Delegated Report		Analysis sheet		Expiry Date:		03/05/2016	
(Members Briefing)		N/A / attached		Consultation Expiry Date:		28/04/16	
Officer				Application Number(s)			
John Diver				2016/1280/P			
Application Address				Drawing Numbers			
45 Twisden Road London NW5 1DL				See draft decision notice			
PO 3/4		Area Team Signature		C&UD		Authorised Officer Signature	
Proposal(s)							
Installation of roof terrace railings and decking to upper floor at rear (part retrospective)							
Recommendation(s):		Grant conditional planning permission					
Application Type:		Householder Application

Address:
45 Twisden Road
London
NW5 1DL

Proposal:
Installation of roof terrace railings and decking to upper floor at rear (part retrospective)
Drawing Nos: (Prefix: 168...) 100, 200, 300, 400, 500, D01.

(5) View from Twisden Road (looking South West)

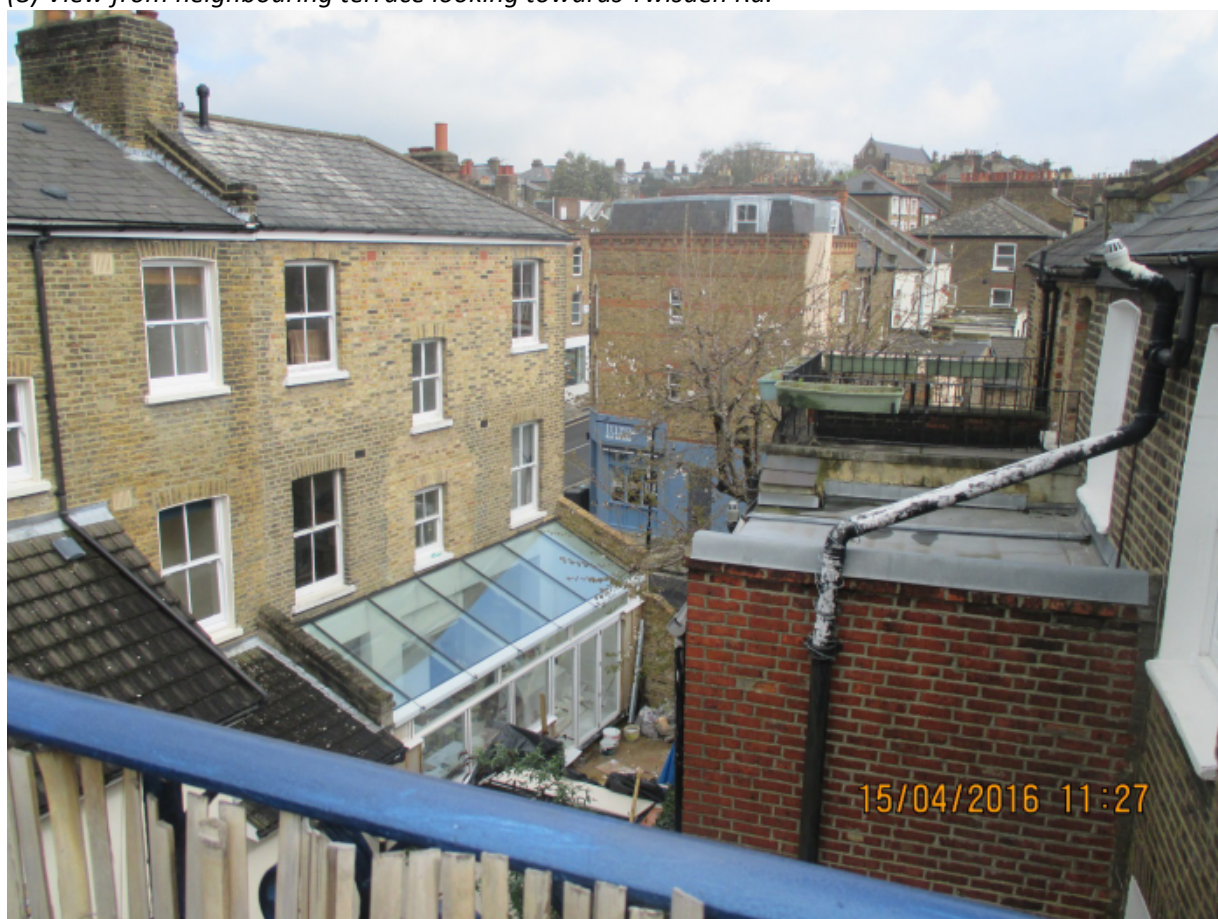
- 2.6. From the only public view of the terrace (from near to the junction with Twisden Road and Chetwynd Road as seen in picture 5), the terraces at no.51 and 47 are much more prominent than the terrace hereby under assessment. Due to its height and the screening effect of the reed/rush trellising behind the railings at no.47, the terrace is not overly visible from this viewpoint. Furthermore a large mature tree in the rear garden of no.51 will obscure the majority of the terrace from public view whilst in leaf.
